July 19, 2002
Work Plan 0274.W1 Addendum
RGA Job # WEST7698

SUBJECT: SUBSURFACE INVESTIGATION WORK PLAN ADDENDUM
Fuel Leak Case R00000319
Former Western Stucco Products
5115 East Eighth Street
Oakland, California 94601

FIGURE 2
 SITE PLAN
 Western Stucco Products
 5115 East Eighth, Oakland, California

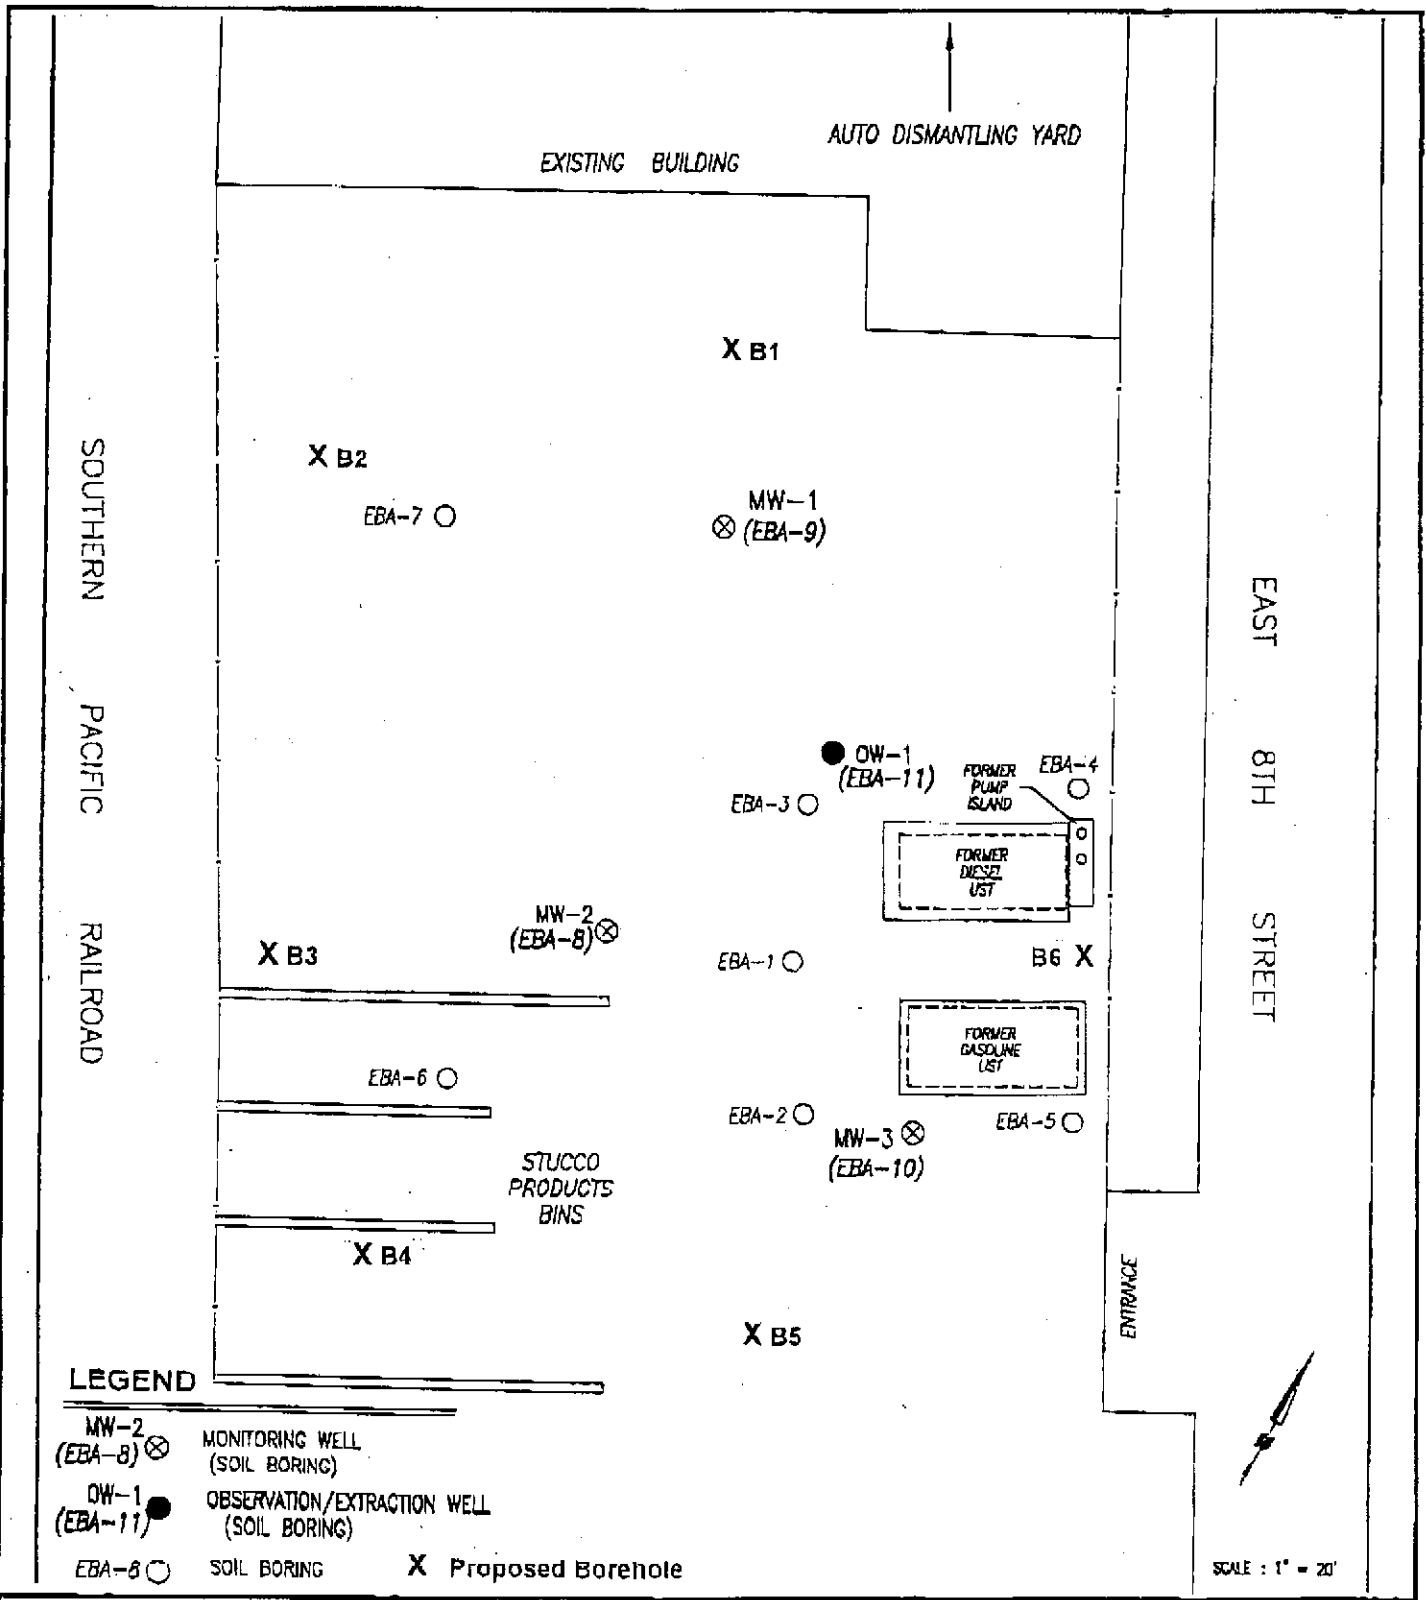
RGA Environmental, Inc. (RGA) is pleased to present this work plan addendum for the Subsurface Investigation Work Plan dated July 16, 2002 for the subject site. In accordance with your July 18, 2002 fax transmittal, the number of boreholes has been increased from five to six, and the locations of the boreholes have been amended as shown on the attached Site Plan, Figure 2. Borehole drilling and sample collection procedures will be as set forth in the July 16, 2002 work plan.

In addition, one soil sample will be collected at a depth of three feet below the ground surface from each of boreholes B1, B2 and B3. The samples will be collected into a brass tube using a slide hammer and a stainless steel sampler. All sampling equipment will be cleaned with an Alconox solution followed by a clean water rinse prior to use in each borehole. The brass tube will be completely filled to eliminate any head space. The ends of the tube will be covered sequentially with aluminum foil and plastic endcaps. After labeling, the tubes will be stored in a cooler with ice pending delivery to McCampbell Analytical, Inc. Chain of custody procedures will be observed for all sample handling. The samples will be analyzed as follows.
